APPEAL SUMMARY

Appeal ID: 14732	Project Address: 2859 SE Rodney Ave
Hearing Date: 3/8/17	Appellant Name: Robert Saladoff
Case No.: B-003	Appellant Phone: 541-601-9031
Appeal Type: Building	Plans Examiner/Inspector: Bill Quillin
Project Type: commercial	Stories: 2 Occupancy: B, A Construction Type: V
Building/Business Name: Miracle Revival Church	Fire Sprinklers: No
Appeal Involves: Addition to an existing structure	LUR or Permit Application No.: 16-292740-LU
Plan Submitted Option: mail [File 1]	Proposed use: egress stair

APPEAL DECISION

MIRACLE REVIVALS, INC CHURCH STAIR
2859 NE RODNEY AVE
PORTLAND, OREGON 97212

A2

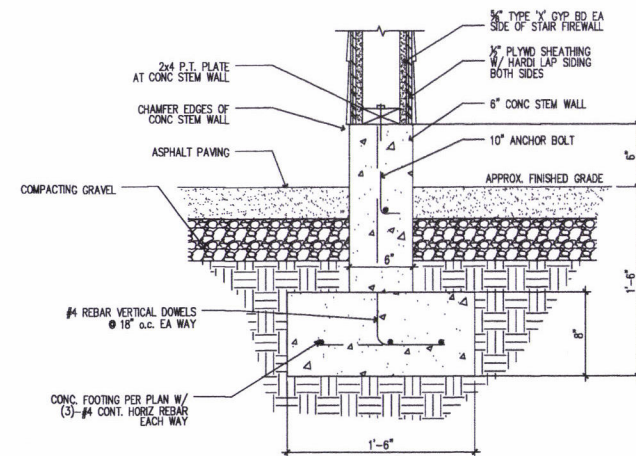
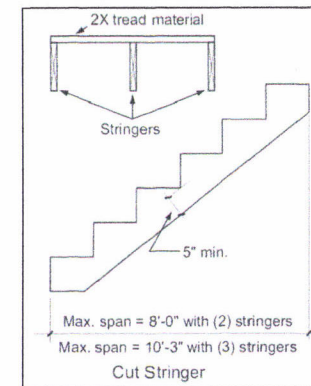
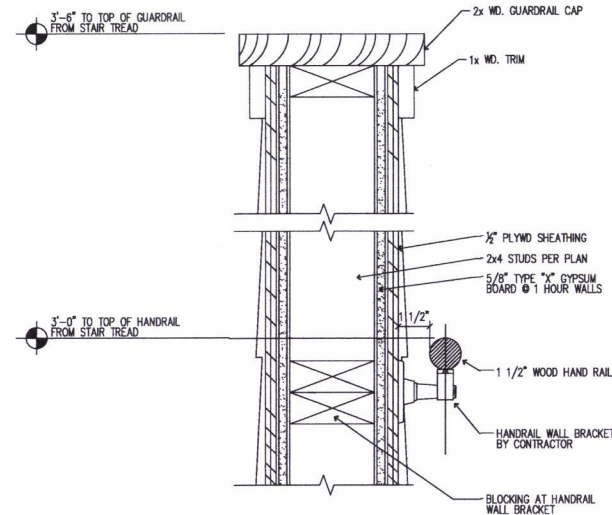
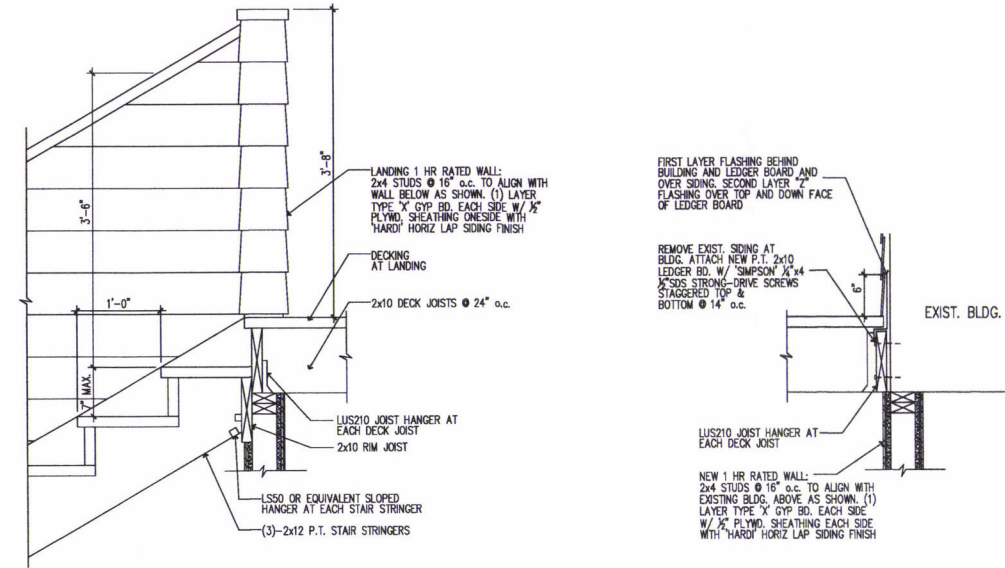
The stair will be 9'-3" from the westerly property line at its closest point, and 3'-1 1/2" from the existing church at its closest point. The upper stair landing will be connected to the existing church outside exterior egress door. See plans for details and more information.

It is important to note that during design development for the project, we met with Building Plans Examiner, Bill Quillin, who informed us of the requirements for the stairway. He directed us to provide a 1-hour fire -assembly for the stair up to 42" above the stair nosings on all sides. Our current design reflects his direction of that meeting on 8/16/16 (his notes are of the record).

Exterior exit stair within 10' of property line, protected to guardrail height: Granted as proposed.

Omission of rated separation between exterior exit stair and church interior: Granted as proposed.

STAIR ELEVATION - NORTH
(ALT. WITH 7'-0" WALL @ STAIR)

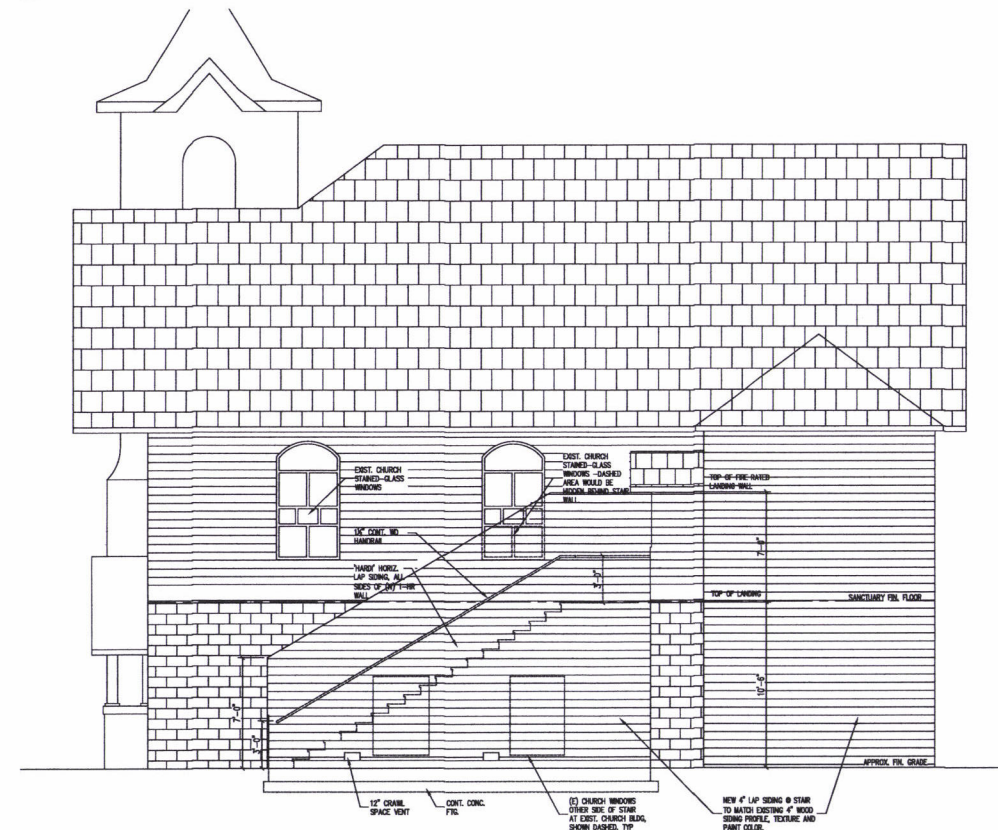
The proposed design allows the existing church exterior to remain as is while providing a needed secondary, safe egress for occupants. The suggested changes by the senior plans examiner, namely heightening the perimeter of the stair to 7'-0" and the enclosing or removing of existing church window openings, would have an adverse affect on the existing historic church and be in

direct conflict with the historic review regarding the continuity of historic character, features and materials for the church.
